Date: November 4, 2019
To: Beth Callahan, Project Manager, Maine Department of Environmental Protection
Karem Gungor, Environmental Engineer, Maine Department of Environmental Protection
From: Elizabeth M. Ransom, P.G. Ransom Consulting, Inc.
Subject: Nordic Aquafarms, Inc., Land-based Aquaculture Facility, Belfast, Maine
L-28319-26-A-N, Review Comments

Project No.: 171.05027

This memo provides responses to the Technical Review Memorandum from Karem Gungor to Beth Callahan dated October 3, 2019. For clarity, the entire comment from the technical memorandum has been copied below and italicized. Responses are in regular text, and on the attached plans and figures as referenced below.

Revised Detail Drawing CE505

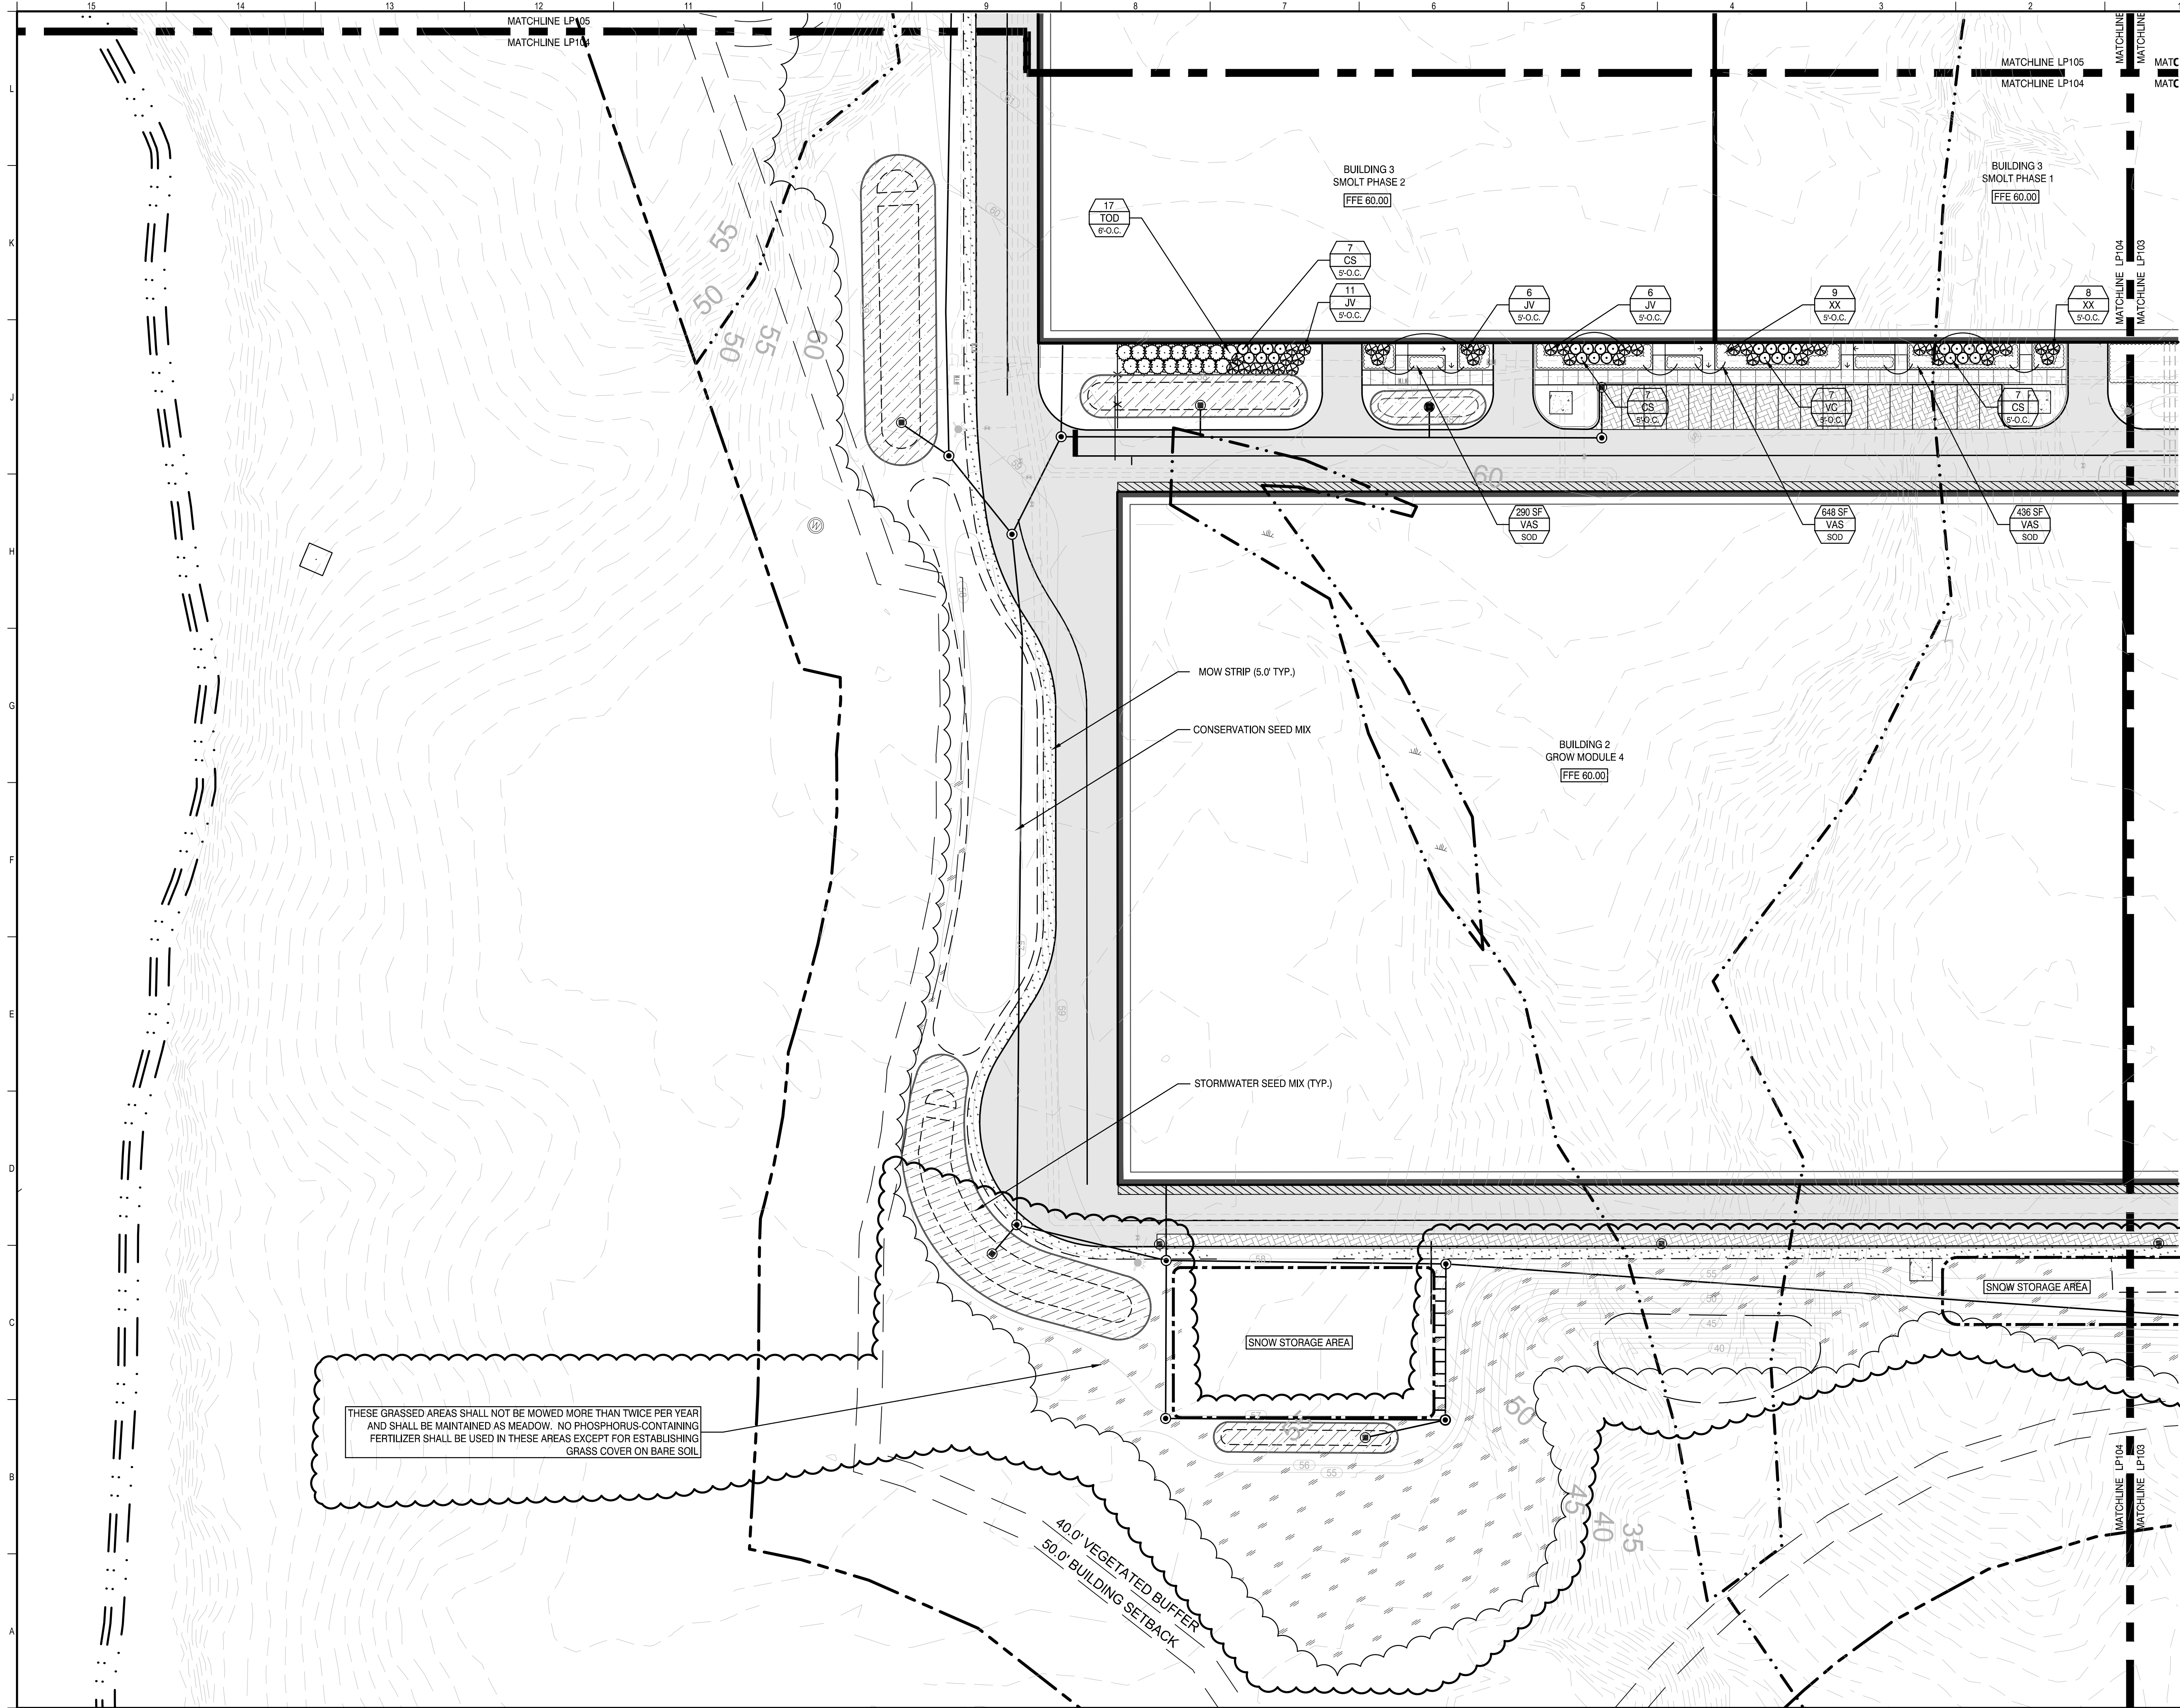
8. Please provide a detail of the temporary structure which will divert the peripheral surface runoff away from the building pad excavation.

A diversion detail has been added to Sheet CE505 (Detail ESC-23). The revised Sheet CE505 is included as **Attachment E**.

PLANTING PLAN
AREA D

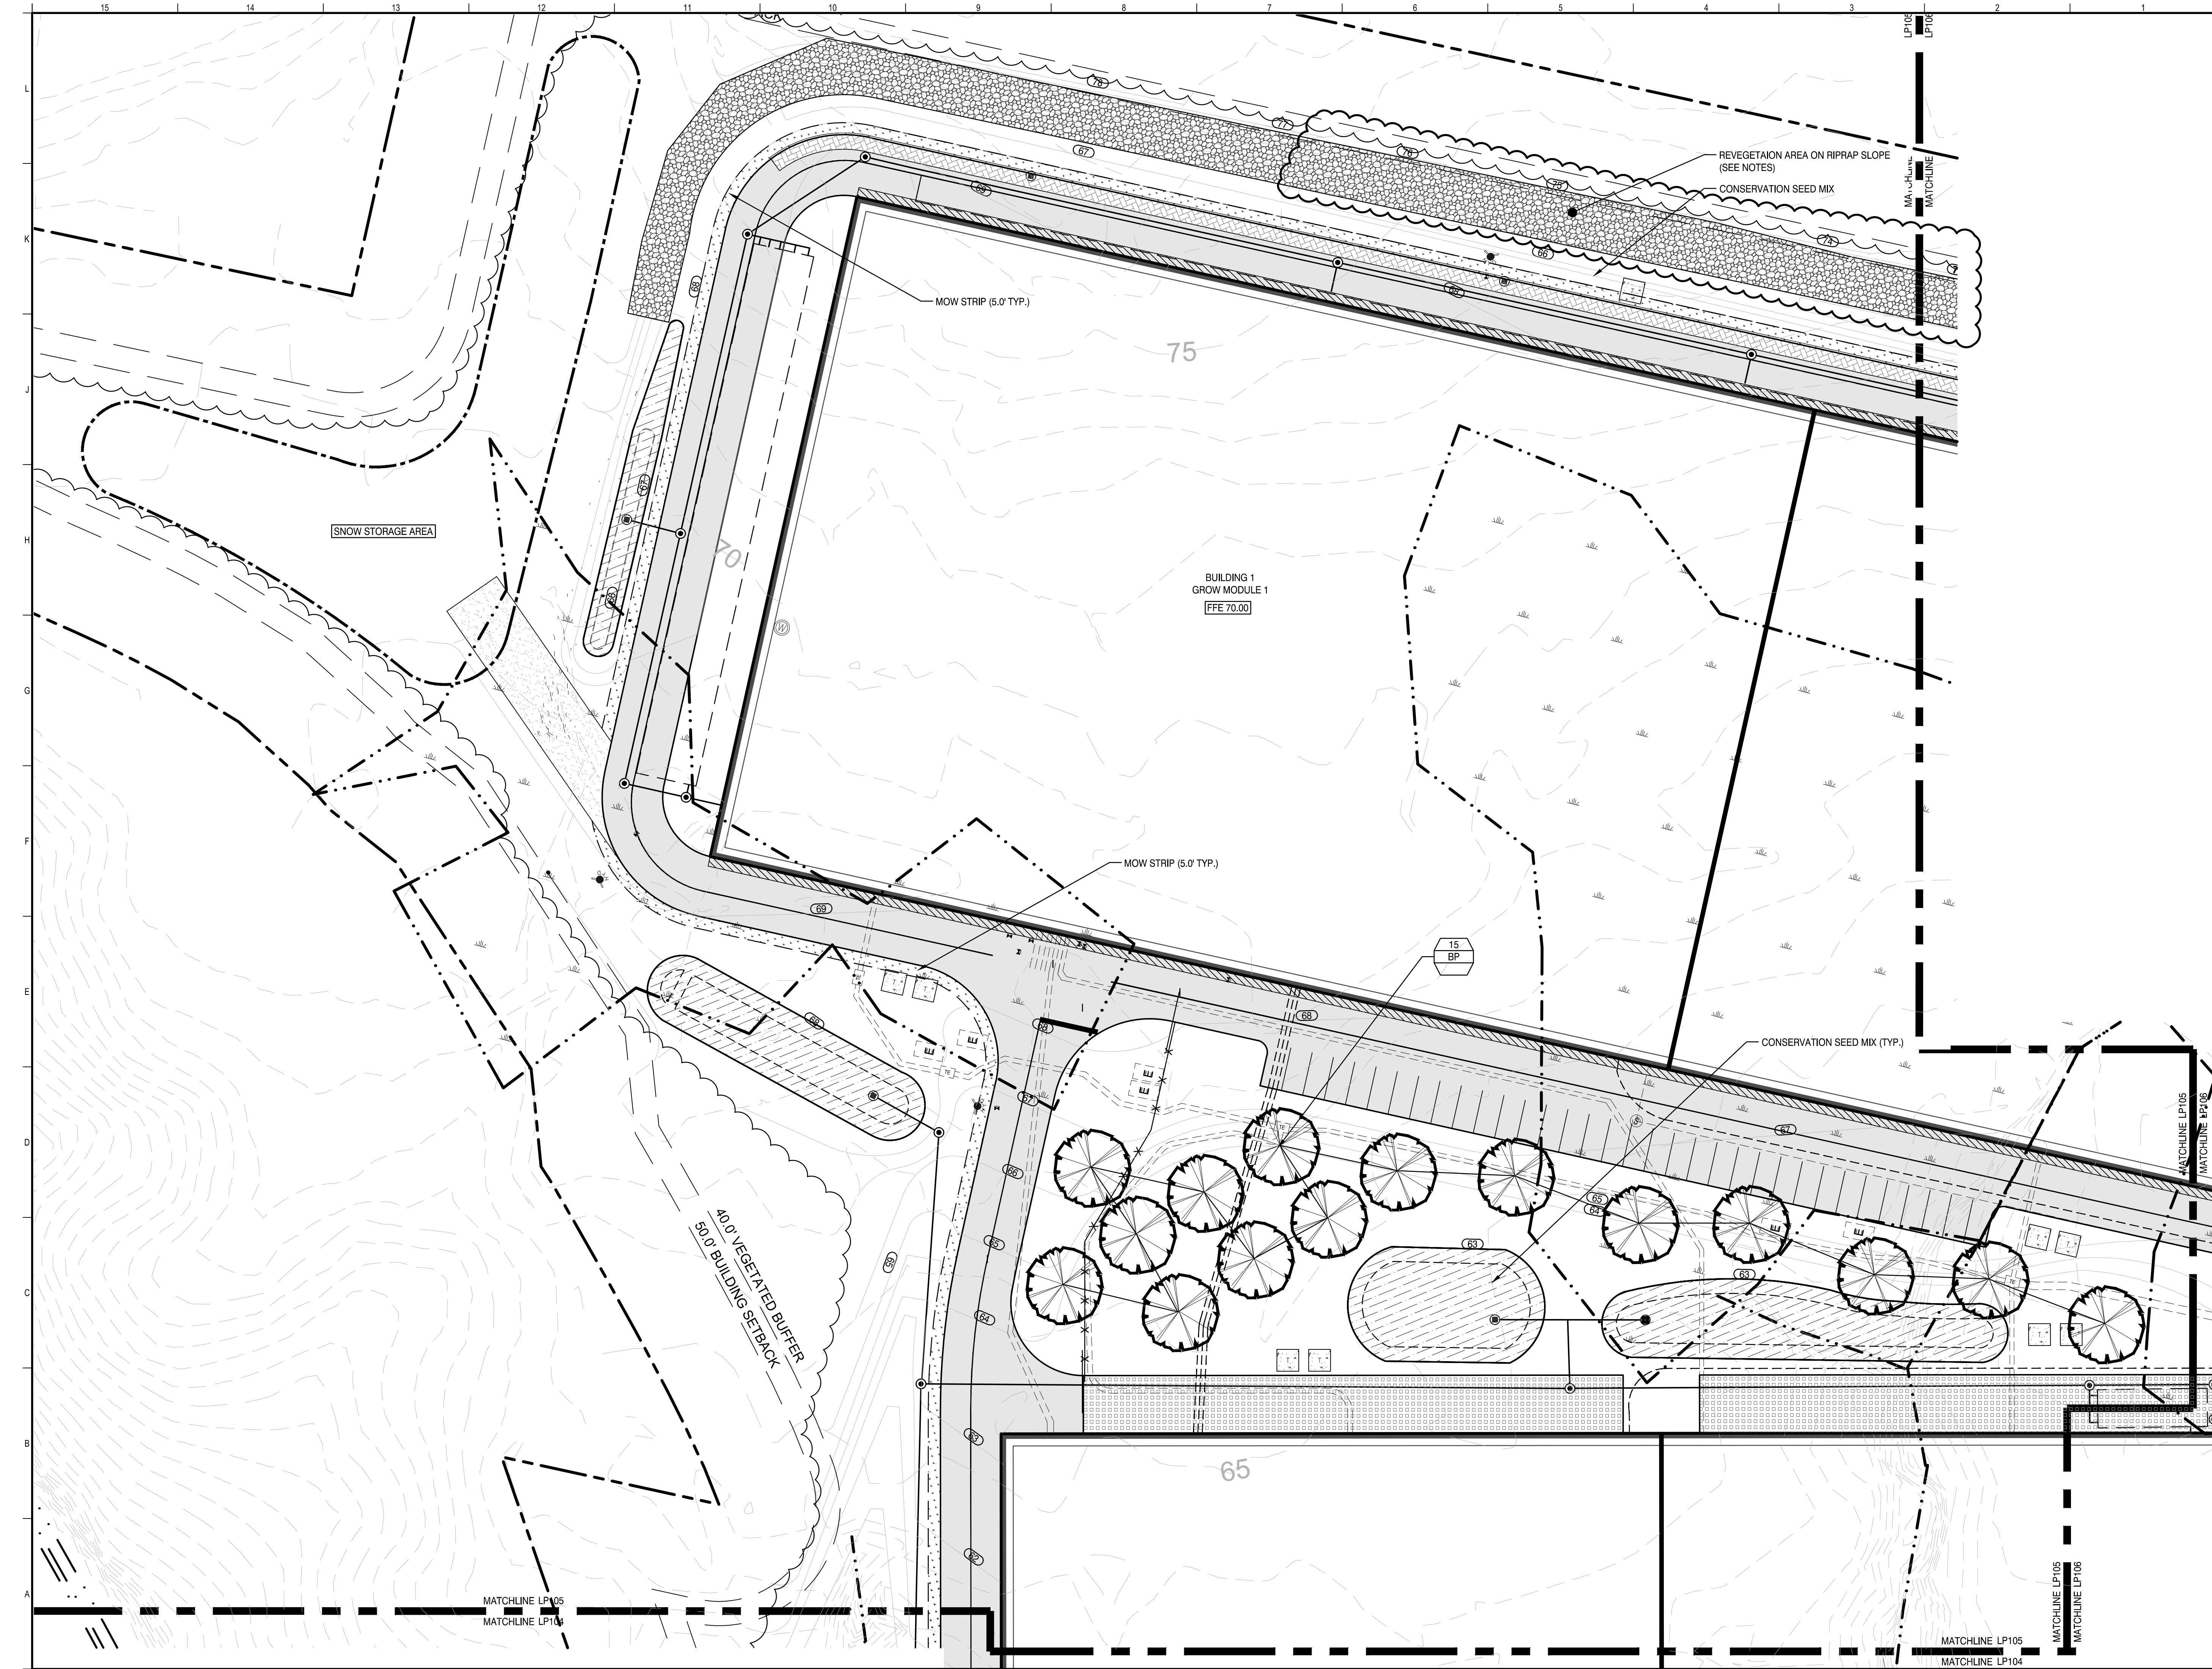
10. The post-development subcatchments 23, 25, and 31 discharge into "Belfast Reservoir One" as shown in Sheet CW-104. In order to eliminate the phosphorus export from the developed areas of these subcatchments into the reservoir, please:

a. Delineate the grassed areas within Subcatchments 25 and 31 in Sheets LP102, LP103, and LP104 and provide the following note for the delineated areas:

"These grassed areas shall not be mowed than more than twice a year and maintained as meadow. No phosphorus containing fertilizer shall be used in these areas except for establishing grass cover on bare soil."

The plans have been updated to include the language regarding fertilizer and maintenance. See attached Landscape Plans (**Attachment F**).
